City of Puyallup Traffic Scoping Worksheet

DEVELOPMENT REVIEW TEA	M (DRT) LETTER
DRT #	1
PERMIT #	PLPSP20230072
PROJECT NAME	Puyallup Medical Office Building
PERMIT TYPE	Preliminary Site Plan
PROJECT DESCRIPTION	4 levels of medical / general office floors over 2 levels of structured parking. Event space and retail also included.
SITE ADDRESS	1617 S MERIDIAN, PUYALLUP, WA 98371;
PARCEL#	7790000140;
ASSOCIATED LAND USE PERMIT(S)	PLPRE20220159
APPLICATION DATE	June 25, 2023
APPLICATION COMPLETE DATE	August 14, 2023
PROJECT STATUS	Active Development Review Team (DRT) review case –
	resubmittal required. Please address review comments below and
	resubmit revised permit materials and by responding in writing to
	the remaining items that need to be addressed.
APPROVAL EXPIRATION	N/A – Active permit application, not approved
CONDITIONS	Active permit application, not approved;
	Pursuant to PMC 20.11.022 regarding inactive applications, any and all pending land use applications or plat applications shall be deemed null and void unless a timely re-submittal is made to the City within 1 year of issuance of this Development Review Team (DRT) comment letter.

2023.017 - Puyallup Medical Office

TABLE 1 - TRIP GENERATION SOUTH MERIDIAN MEDICAL/GENERAL OFFICE - PUYALLUP TRAFFIC SCOPING WORKSHEET

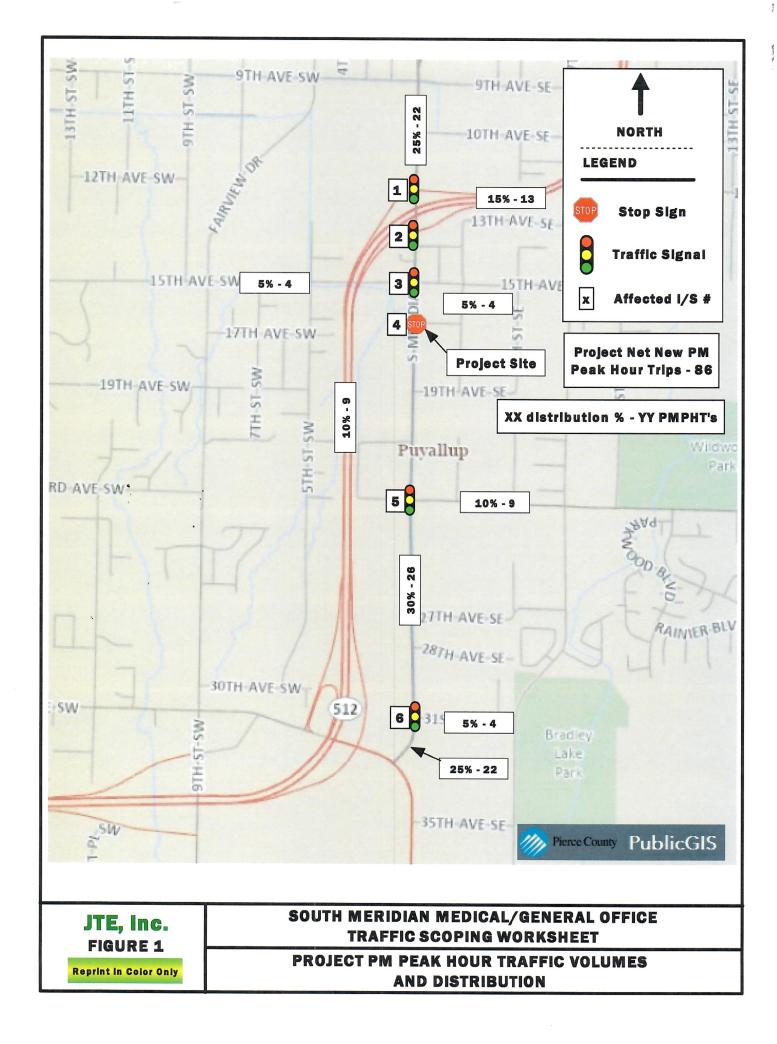
The scoping worksheet needs to use gross floor area for estimating trip generation per ITE.

This site not located within the Good Samaritan Hospital campus and is not immediately adjacent to campus property. Use the stand-alone rates for LUC 720.

Per ITE, there are no pass-by trips for LUC 720. Please recalculate trip generation by removing pass-by rates for this land use. Office agencies allow 25%

The scoping worksheet assumptions are not consistent with architect drawing package

Day spa, event space, have not been accounted for. All land uses must be included in trip generation calculations.

Deep tissue messes is a medical treatment.

Need more information on possible end user of retail space. Application describes as "future tenant space for either retail or service-type business: There's a lot of variability within this type of land uses.

I have prepared the attached updated City of Puyallup Scoping in response to City comments.

I treated the Service item as a Medical Massage use and added the SF to the MOB calculations. The Retail/Deli use was identified as a Fast Casual Restaurant use LUC 930, this use is similar to a high turnover Sit – Down Restaurant that has 43% pass-by rate.

The event space activity is presumed to occur on weekends and evenings after 1900.
